Title - Sujet Radar Hill Viewpoint Shelter	
Solicitation No. - N° de l'invitation EZ899-160310/A	Amendment No. - N° modif. 001
Client Reference No. - N° de référence du client	Date 2015-06-30
GETS Reference No. - N° de référence de SEAG PW-\$PWY-022-7533	
File No. - N° de dossier PWY-5-38035 (022)	CCC No./N° CCC - FMS No./N° VME
Solicitation Closes - L'invitation prend fin at - à 02:00 PM on - le 2015-07-13	Time Zone Fuseau horaire Pacific Daylight Saving Time PDT
F.O.B. - F.A.B. Plant-Usine: <input type="checkbox"/> Destination: <input checked="" type="checkbox"/> Other-Autre: <input type="checkbox"/>	
Address Enquiries to: - Adresser toutes questions à: Arthur (PWY), Carolyn	Buyer Id - Id de l'acheteur pwy022
Telephone No. - N° de téléphone (604) 775-6667 ()	FAX No. - N° de FAX (604) 775-6633
Destination - of Goods, Services, and Construction: Destination - des biens, services et construction: Parks Canada - Pacific Rim National Park - Tofino, BC

Amendment 001

Radar Hill, BC
Radar Hill Viewing Shelter
2015-06-30

ADDENDUM #1

NEW TOP SOUTH PLATFORM PLAN REVISED
SECTION 1 REVISED
(REFER TO DWG. S201)

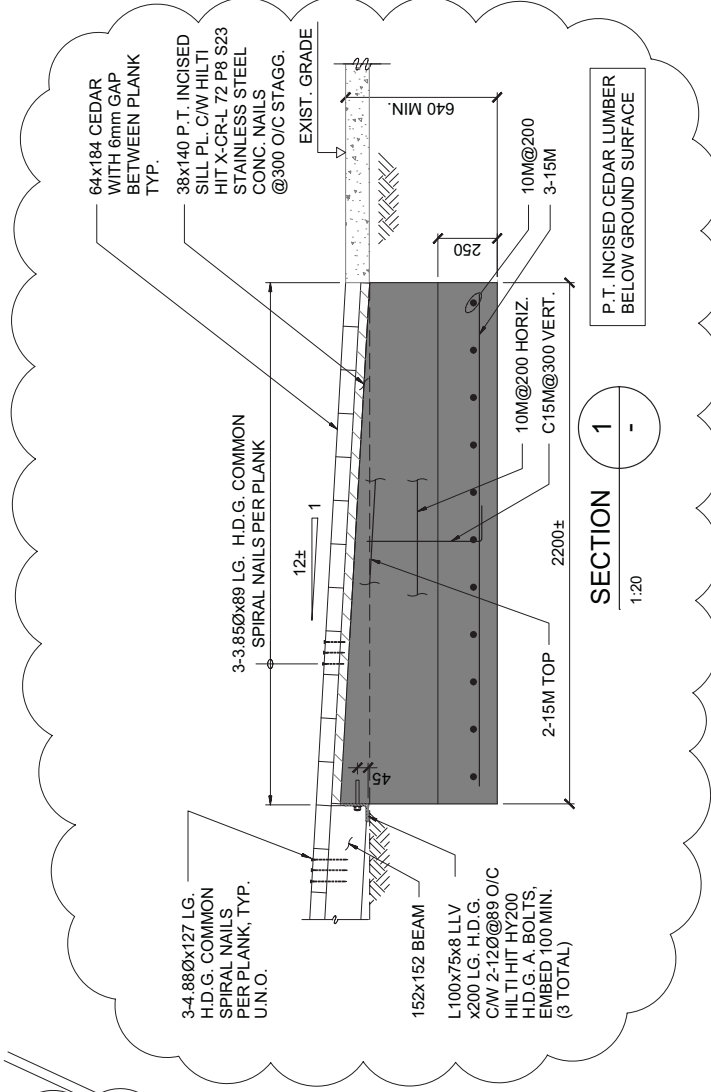
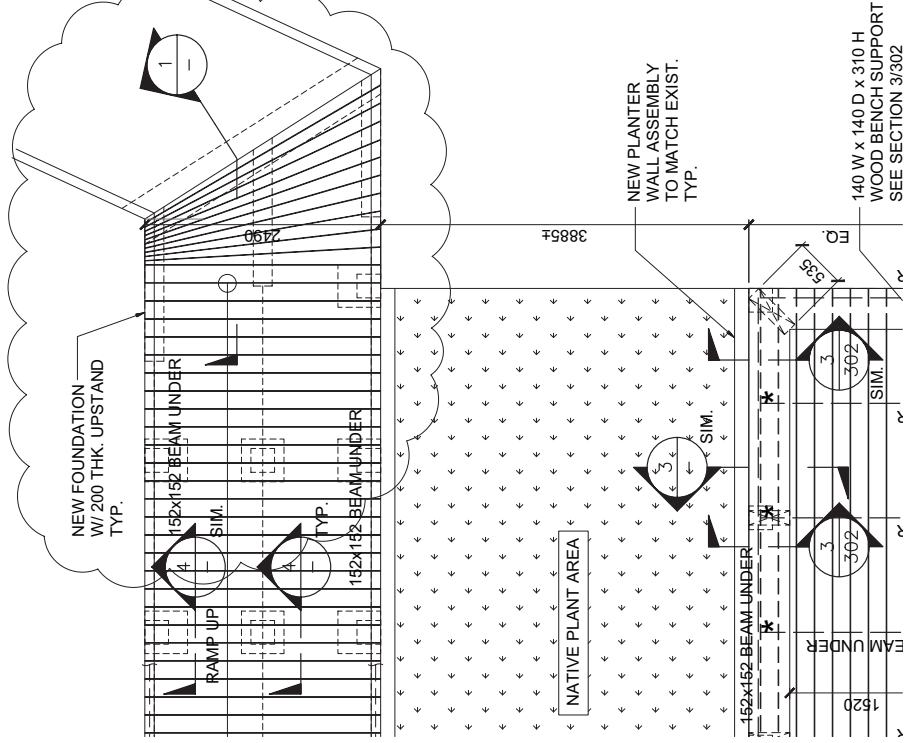
- 2.1 **Add** ramp slope up from East to West to Existing & New Top South Platform.
- 2.2 **Revise** plan & section 1/201 as per sketch AD01.
- 2.3 **Revise** frost protection to base of footing to 600min. as per section 4/201.

SECTION 1
REVISED

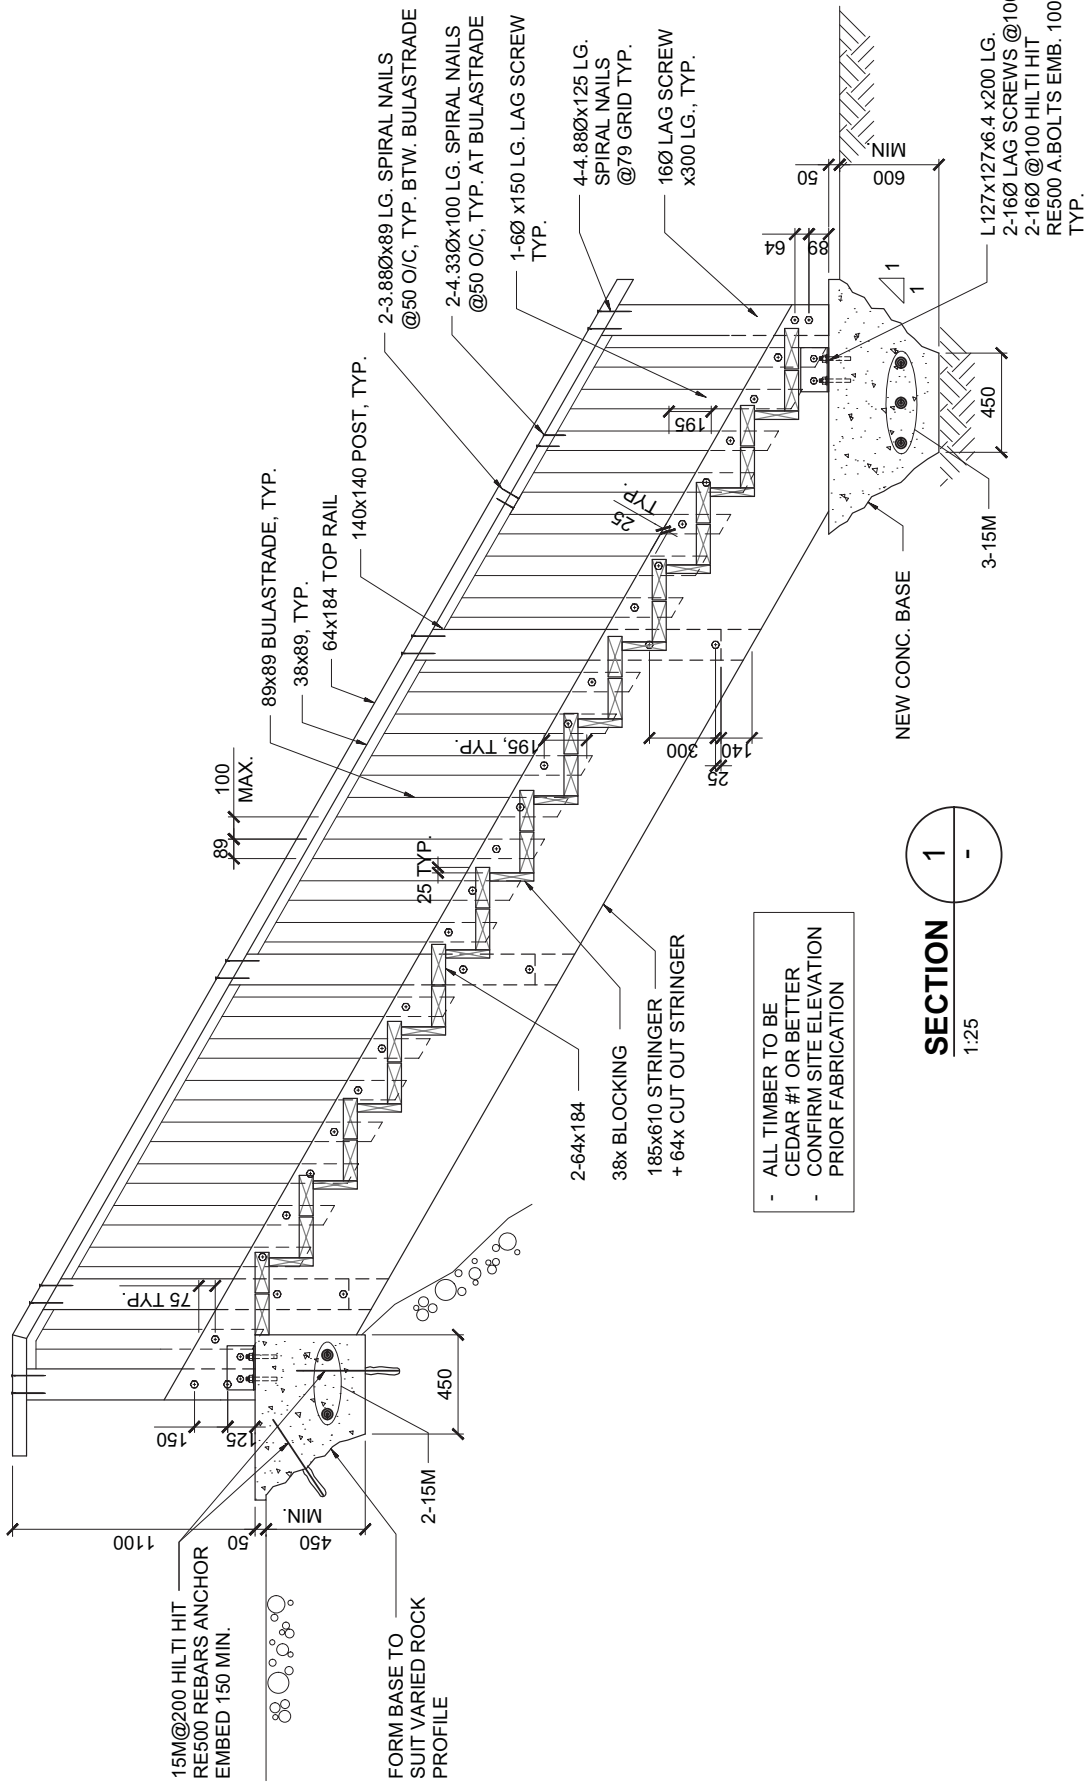
- 3.1 **Revise** width of cut out stringers from 191mm to 184mm of "New Middle Wood Stair".
- 3.2 **Revise** sections 1/202 & 2/202 as per sketches AD02 & AD03 respectively.

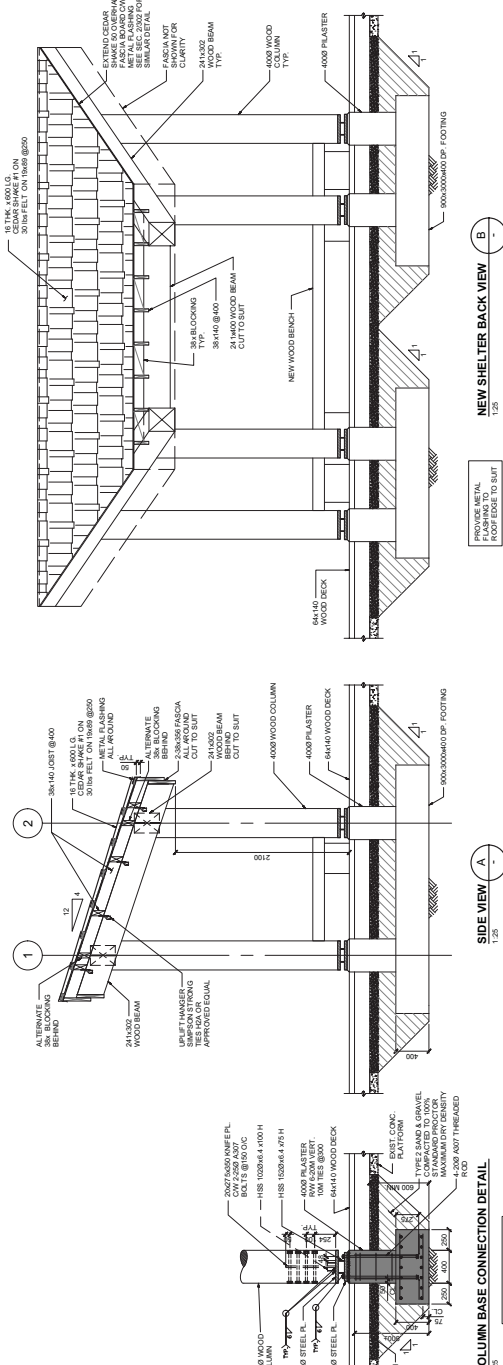
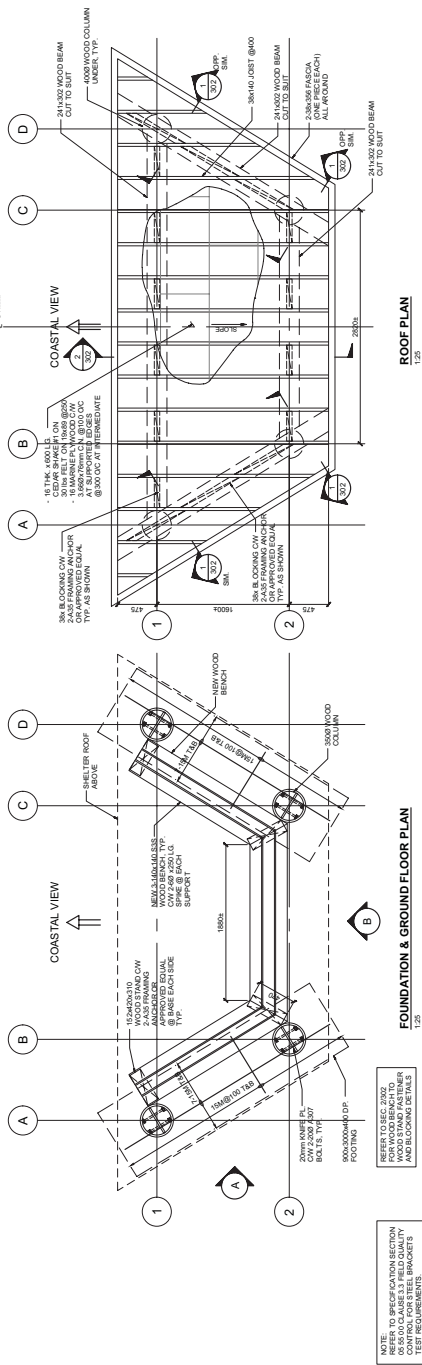
- 5.1 **Revise** shelter sections and details as per sketch AD05.
